Product Change Notification / SYST-08OAYW733

ERRATA - PIC24FJ256GB110 Family Silicon/Data Sheet Errata Document Revision

PIC24FJ256GB110 Family Silicon Errata and Data Sheet Clarification

The PIC24FJ256GB110 family devices that you have received conform functionally to the current Device Data Sheet (DS39897C), except for the anomalies described in this document.

FIGURE 2-3 FREQUENCY vs. ESR PERFORMANCE FOR SUGGESTED VCAP

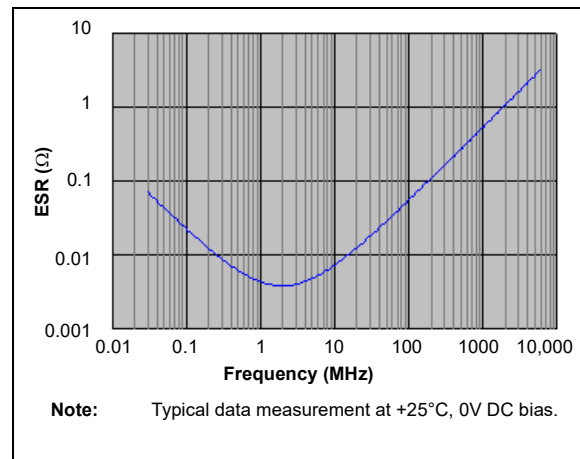
Designers may use [Figure 2-3](#) to evaluate ESR equivalence of candidate devices.

When the regulator is disabled, the VCAP/VDDCORE pin must be tied to a voltage supply at the VDDCORE level. Refer to **Section 29.0 “Electrical Characteristics”** for information on VDD and VDDCORE.

FIGURE 2-4 DC BIAS VOLTAGE vs. CAPACITANCE CHARACTERISTICS

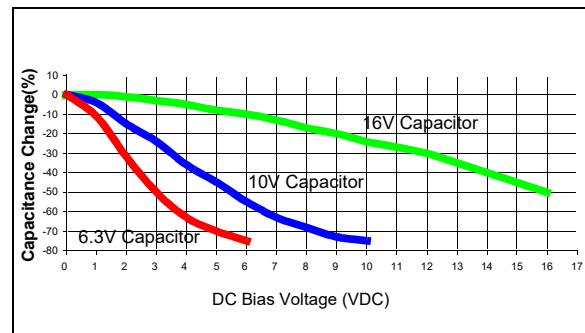
A typical DC bias voltage vs. capacitance graph for 16V, 10V and 6.3V rated capacitors is shown in Figure 2-4.

When selecting a ceramic capacitor to be used with the internal voltage regulator, it is suggested to select a high-voltage rating, so that the operating voltage is a small percentage of the maximum rated capacitor voltage. For example, choose a ceramic capacitor rated at 16V for the 2.5V core voltage. Suggested capacitors are shown in Table 2-1.

FIGURE 29-1: PIC24FJ256GB110 FAMILY VOLTAGE-FREQUENCY GRAPH (INDUSTRIAL)

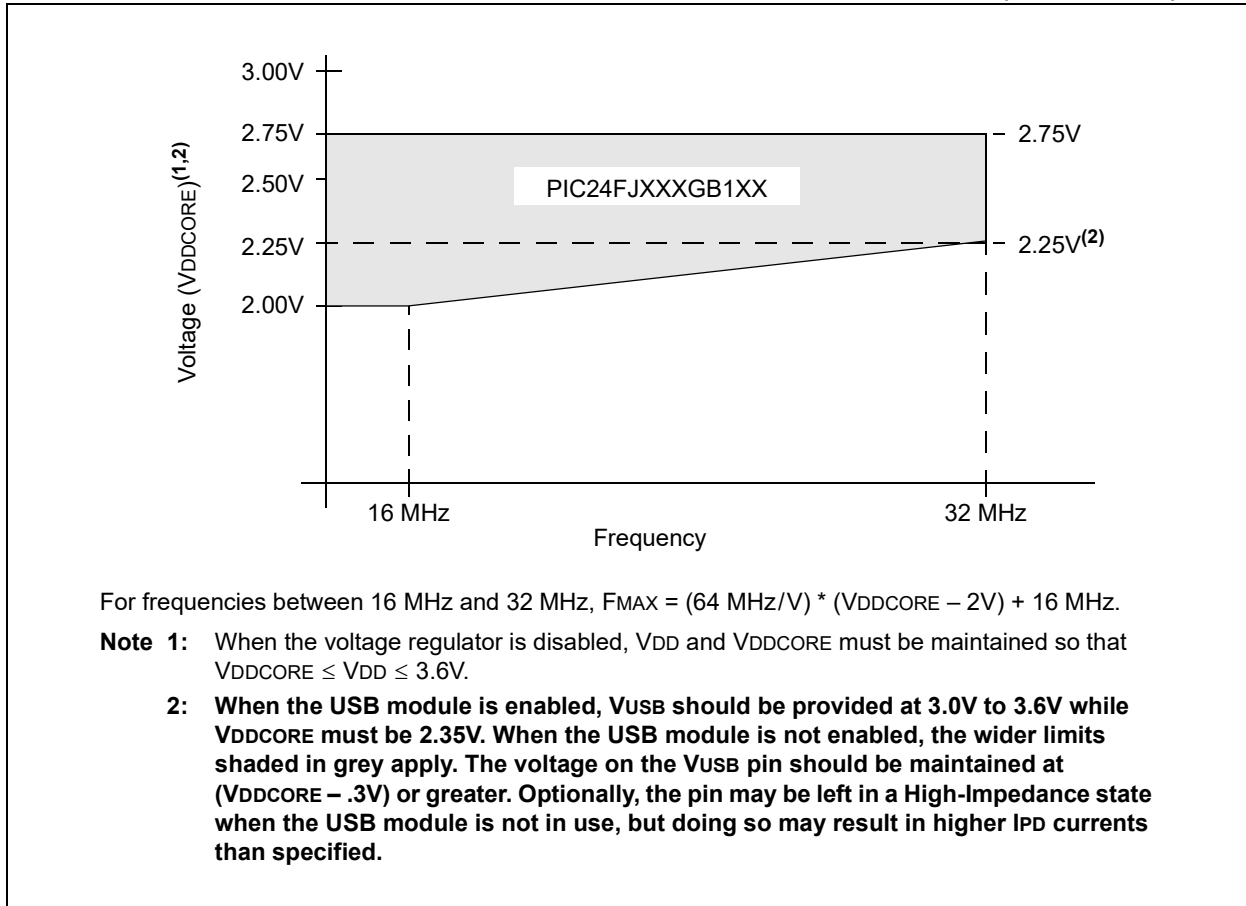
Figure 29-1 (“PIC24FJ256GB110 Family Voltage-Frequency Graph”) is amended by adding an additional footnote. The updated figure is shown below (changes in **bold**; bold in original removed for clarity).
